Application 21/P/00539 Location: 1 Onslow Street, Guildford, GU1 4YS

Proposal: Three storey extension to the roof, roof terrace and external alterations to the existing building including new external elevations and new entrances to Woodbridge Road.

SPD Viewpoint 06: Hogs Back, existing view looking north east (refer to SPD image)

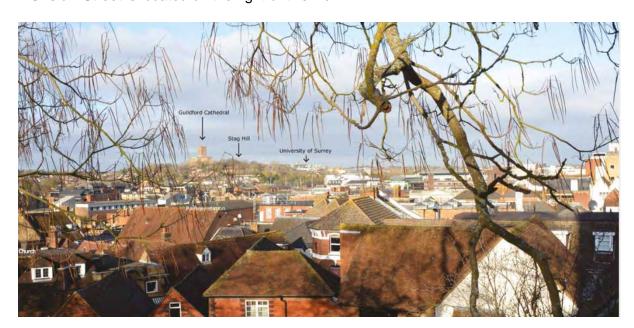
St Saviours Church is evident sitting behind the Onslow House with 1 Onslow Street to the right of the church. The increase mass and bulk of the proposed development should be shown in this view to show the impact on this view and the character of the roofscape of the town. As referred in the SPD the proposal at 1 Onslow Street should not worsen the amount of 'detractor buildings' in the town centre.

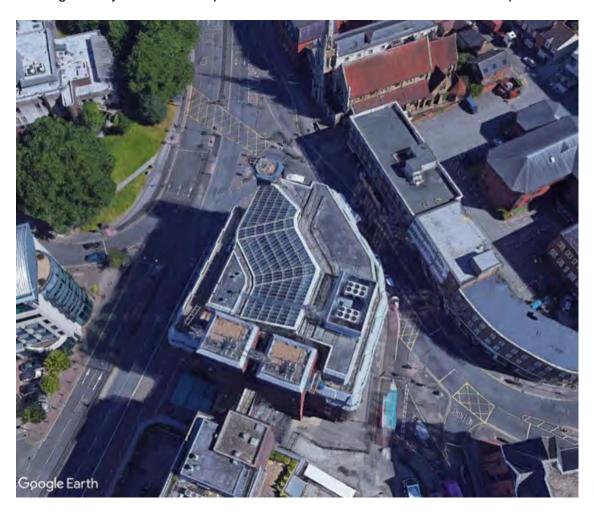
The proposed plan is to move the entrance of the building to be on Commercial Rd just near the junction with Woodbridge Road.

We see little information on how this new entrance gives access to the Town Centre—is it through the bus station or how it relates to the emerging North Street redevelopment proposals.

Also we question the use of the current main entrance which is described as bicycle parking but presumably will also serve as a staff entrance because of its position on Onslow Street and desire line to and from the railway station.
